PLAN REVIEW SHEET

2015-134

Charlotte Merlane FDS

Bus stop pad detail

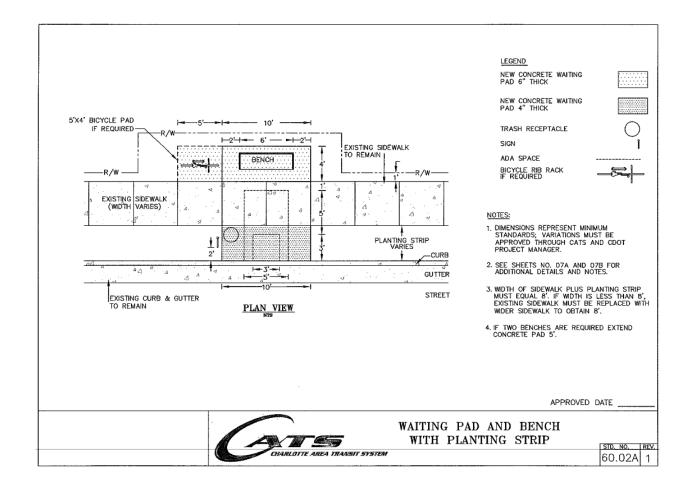
This site is located on a future bus route that will connect to the planned Sugar Creek LYNX Blue Line Station. The Petitioner is requested to provide and construct a bench pad for a new bus stop along Sugar Creek Road.

Below is an image of the standard detail (60.02A) for the requested bus stop pad. Permanent easement is requested, where dimensions exceed existing or proposed right-of-way limits. CATS will be responsible for installation and maintenance of the bench.
